P&Z CASE NO. 428
6400 BLK BROADWAY ST
(6401/6403 & 6421 BROADWAY ST)
REPLAT

NOVEMBER 07, 2022

COMMUNITY DEVELOPMENT

PROPOSED

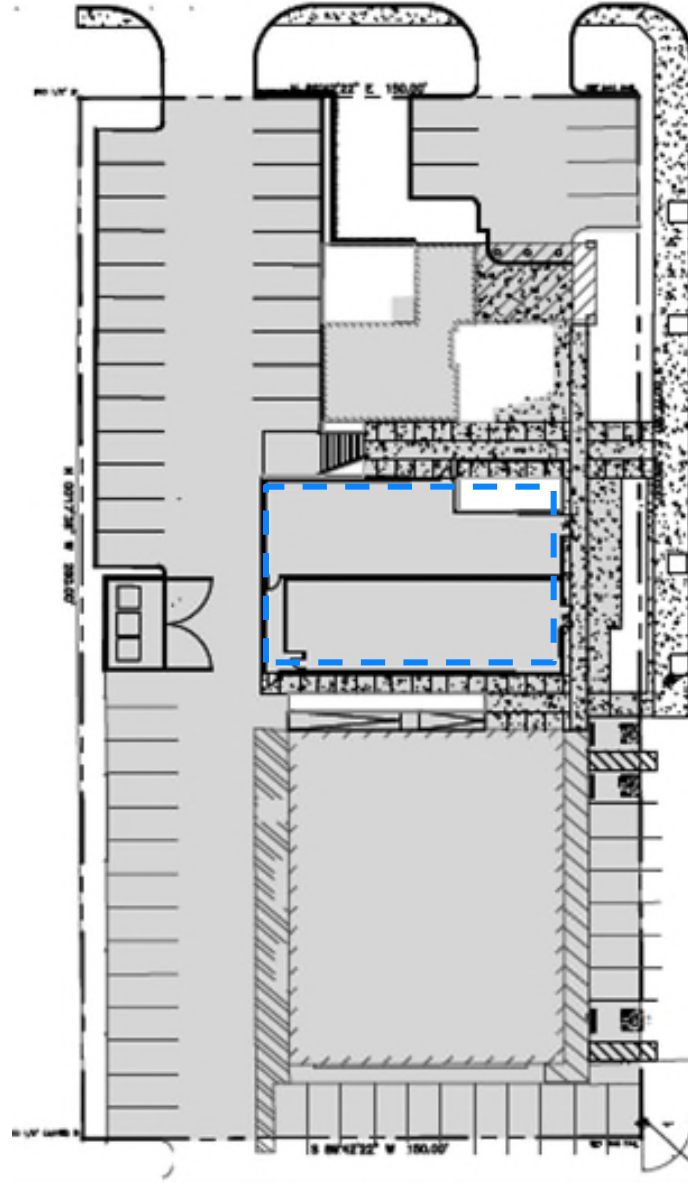
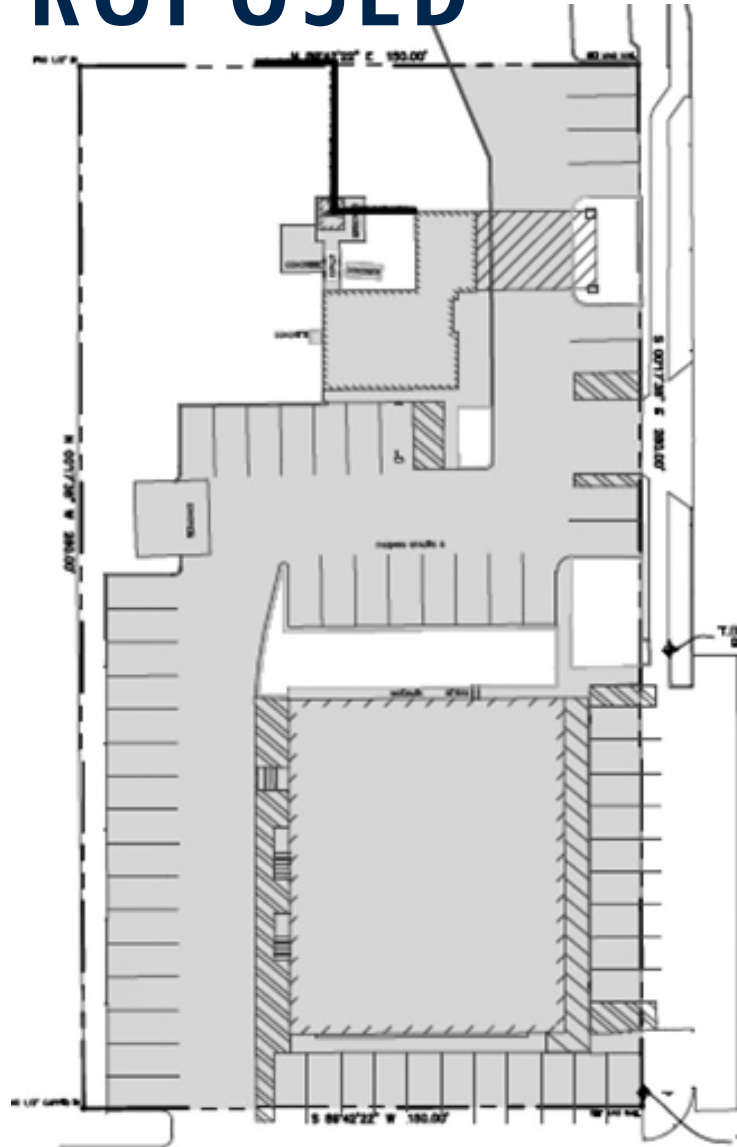
- The replat does not meet Chapter 3 Zoning regulations regarding required landscaping and minimum parking requirements. New improvements are required to conform with current regulations.

- Required plat notes due to nonconformity:
 - Lot 18 does not conform with the minimum required 8ft wide landscape area per Section 3-69(3) of the City's Zoning Code.
 - Lot 18 does not conform with the minimum required 8ft wide landscape area per Section 3-70(1) of the City's Zoning Code.
 - Lot 18 does not conform with the minimum off-street parking requirements per Section 3-84(1) of the City's Zoning Code.
